THIS SHEET HAS BEEN REVISED TO REFLECT 1993 AASHTO AND VAOT SPECIFICATIONS AND STANDARDS	
REVISED DESIGN BY: R. KELM	DRAWN BY: S. SAUCIER
CHECKED BY: J. PAUSKY	DATE: 6/95
BETTIGOLE ANDREWS & CLARK, INC. Consulting Engineers	
STATE OF VERMONT AGENCY OF TRANSPORTATION	
Town Of MORETOWN / MIDDLESEX	Bridge No.
Highway No. VT. RTE. 100B	Log Sta. 212+00
OVER THE WINOOSKI RIVER	
WEST ABUTMENT MASONRY & REINF.	
Designed By RLJ	Drawn By BJAN
Checked By JPH Date 12-86	Bridge Design Supervisor CDB Date 7-87
PROJECT MORETOWN/MIDDLESEX	PROJECT NO. BRS 0167 (11)
I.S.C. Info.	
Bridge Sheet No. BR114	Sheet 206 of 243

PLAN

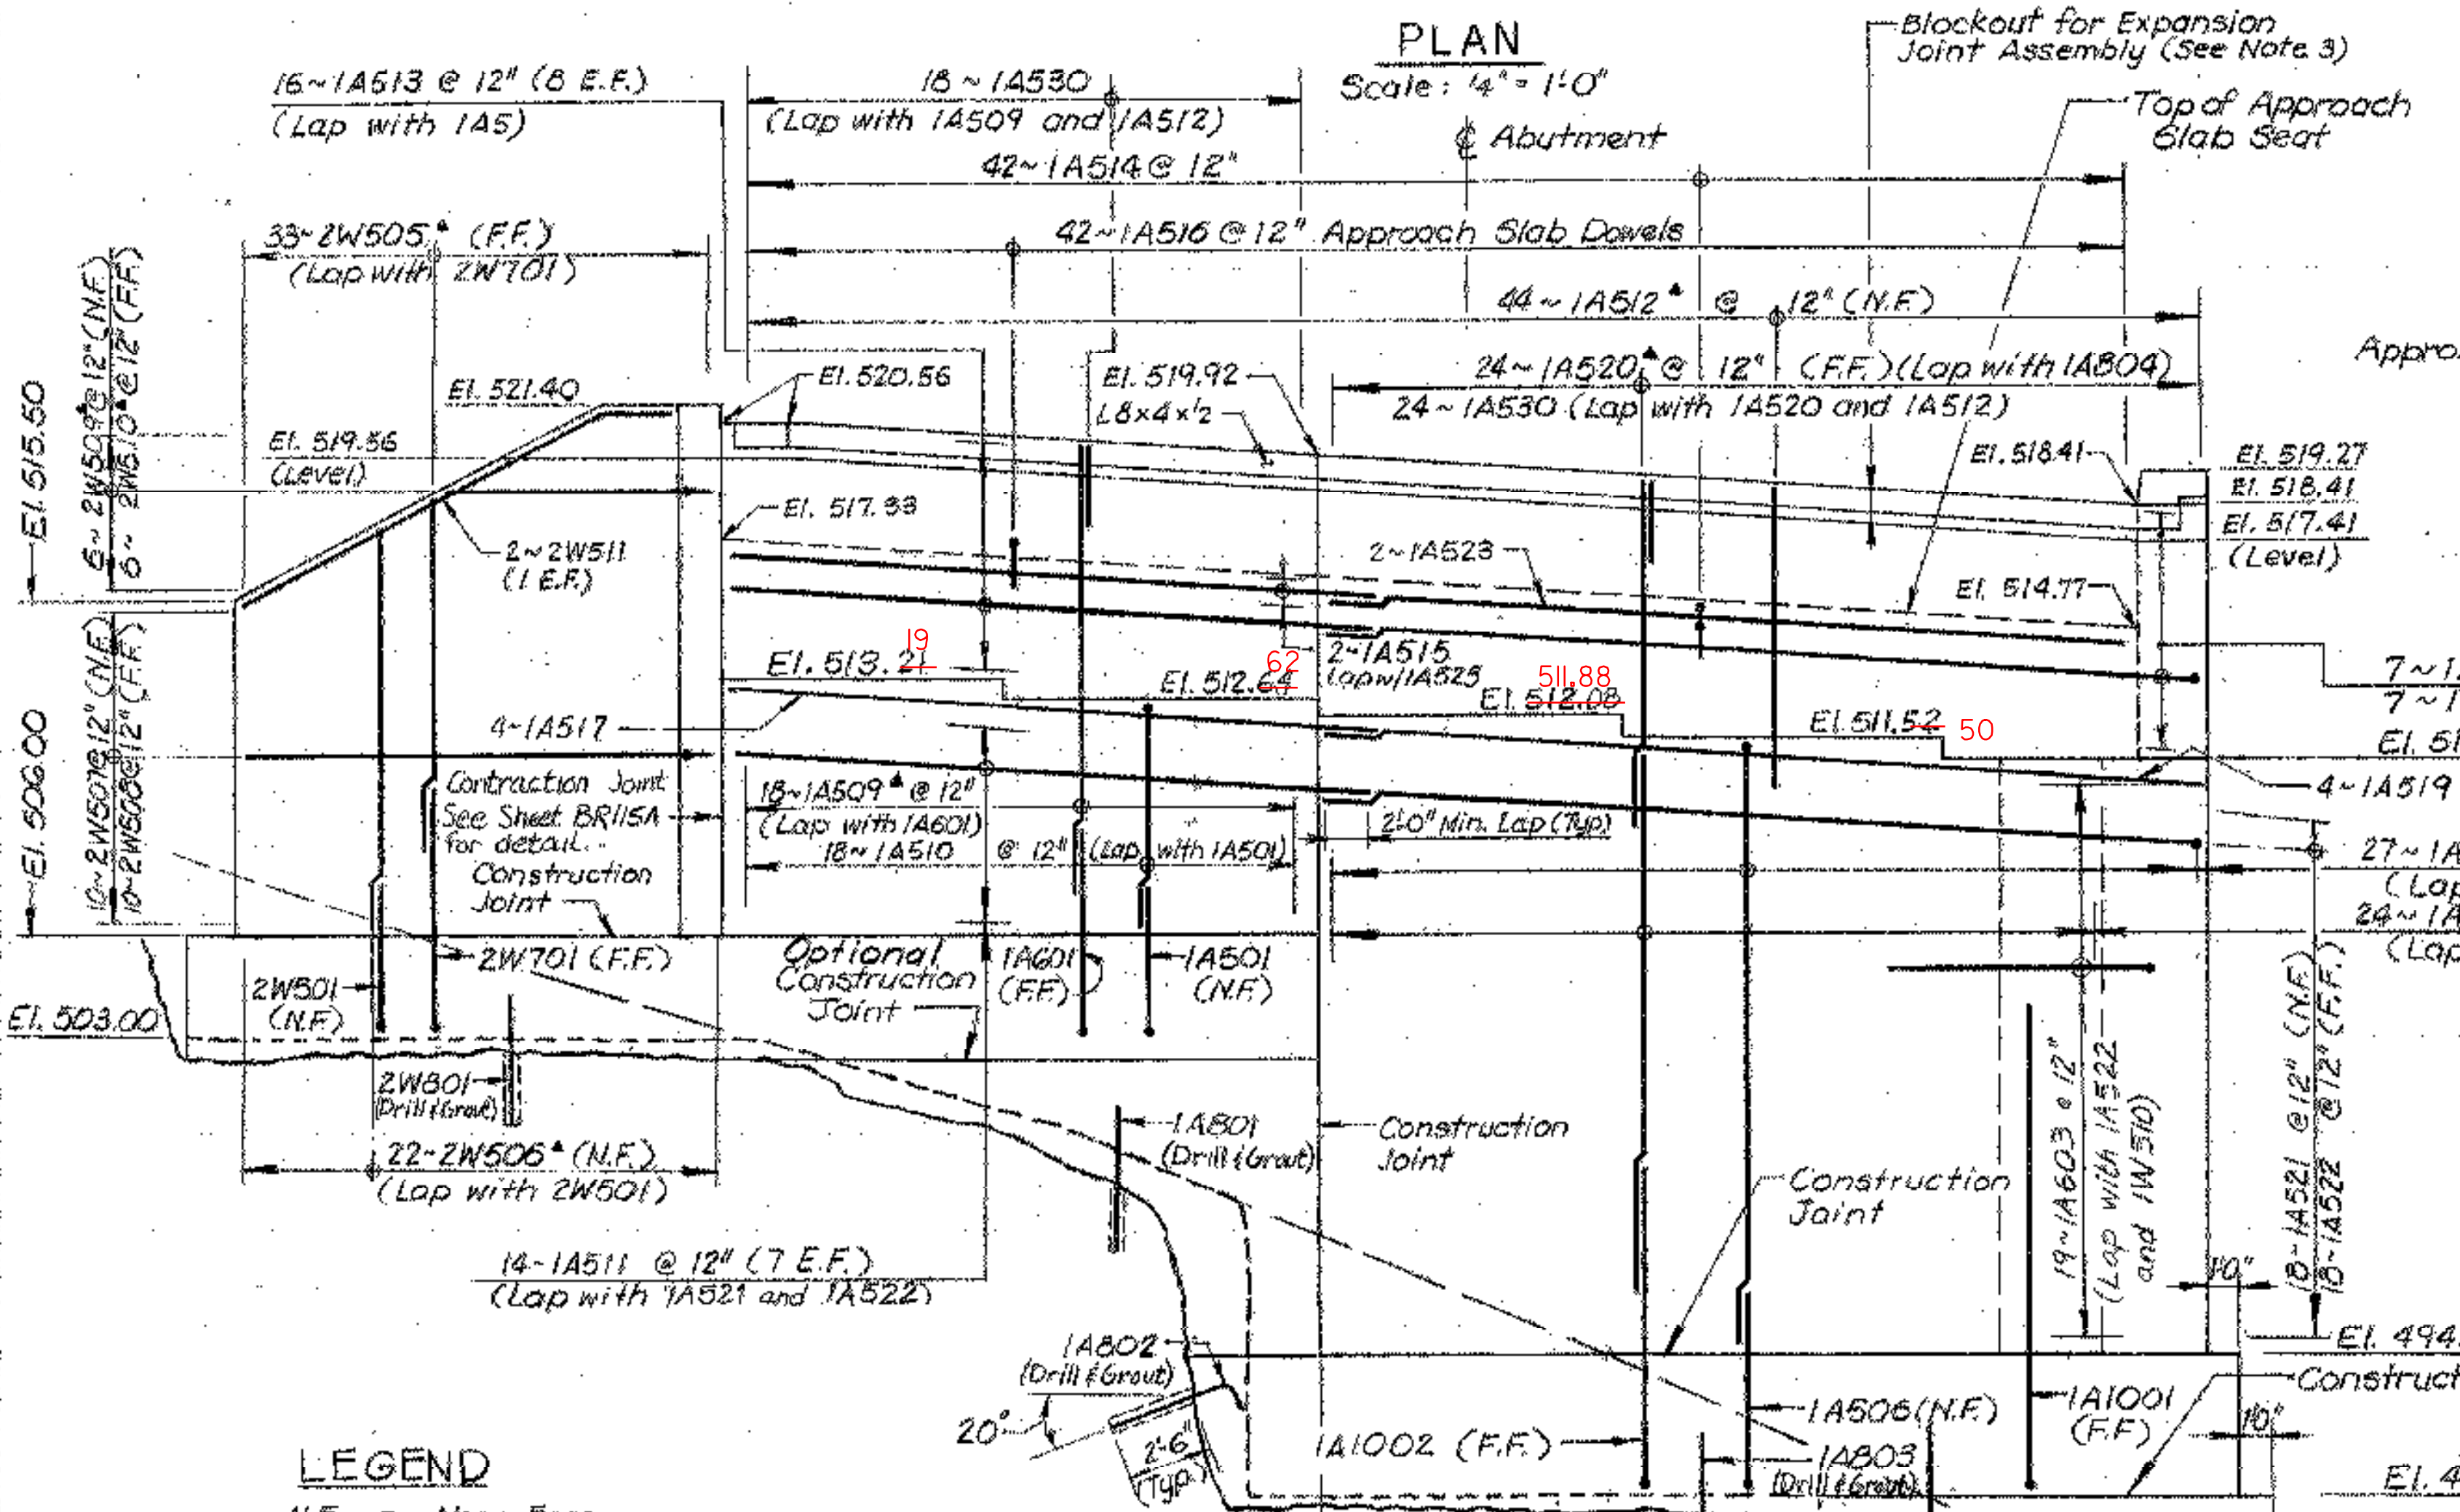
**NEED 19'-4" APPROACH SLAB SEAT ONLY AT WINGWALL # 2 TO MAKE ROOM FOR GUARDRAIL POST.
